# Access Compliance Report

## Public Rights-of-Way

Intersection ID: 42988	Main Street: UNIVERSITY_CITY_BV	Cross Street: UNIVERSITY_WALK_CR	Location: SE
ADA ID: 72D33F42FA8C	Ramp Type: MedianPerp	Initial Pass/Fail: Fail	Overall Compliance: No
Severity Score: 25			
Codes/Mitigation Info/Possible Solution		Field Measurements/Component Compliance

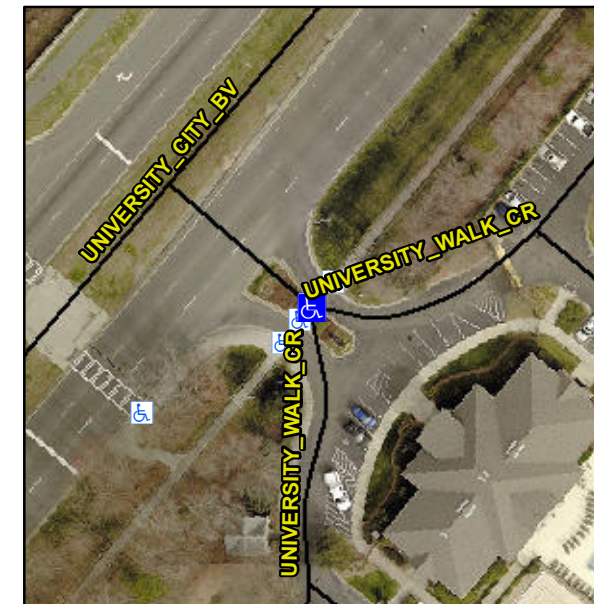
**R304.2.2, R304.5.3**

Compliance	Description	Data	Compliance	Description	Data
N/A	Ramp Length (in)	69.0	No	Ramp Slope (%)	10.0
Yes	Ramp Width (in)	60.0	No	Ramp XSlope (%)	5.1
N/A	Flare Type LT	N/A	N/A	Flare Type RT	N/A
N/A	Flare Slope LT (%)	N/A	N/A	Flare Slope RT (%)	N/A
N/A	Flare Traversable LT?	N/A	N/A	Flare Traversable RT?	N/A
N/A	Landing Length (in)	N/A	N/A	DWS Provided?	N/A
N/A	Landing Width (in)	N/A	N/A	DWS Contrast?	N/A
N/A	Landing Slope (%)	N/A	N/A	DWS Length (in)	N/A
N/A	Landing X Slope (%)	N/A	N/A	DWS Full Width?	N/A
N/A	Landing Curb? (Y/N)	N/A	N/A	DWS Offset (in)	N/A
N/A	Shared Landing?	N/A			
N/A	Gutter Ponding?	N/A	N/A	Gutter Slope (%)	N/A
N/A	Gutter Lip Ht (in)	N/A	N/A	Gutter X Slope (%)	N/A
N/A	Painted X Walk1?	Yes	N/A	Painted X Walk2?	N/A
	X Walk 1 Direction	To SE		X Walk 2 Direction	N/A
N/A	X Walk 1 Width (in)	55.0	N/A	X Walk 2 Width (in)	N/A
	X Walk 1 Slope (%)	0.9		X Walk 2 Slope (%)	N/A
	X Walk 1 X Slope (%)	4.6		X Walk 2 X Slope (%)	N/A

**Remove & Replace Entire Ramp.**
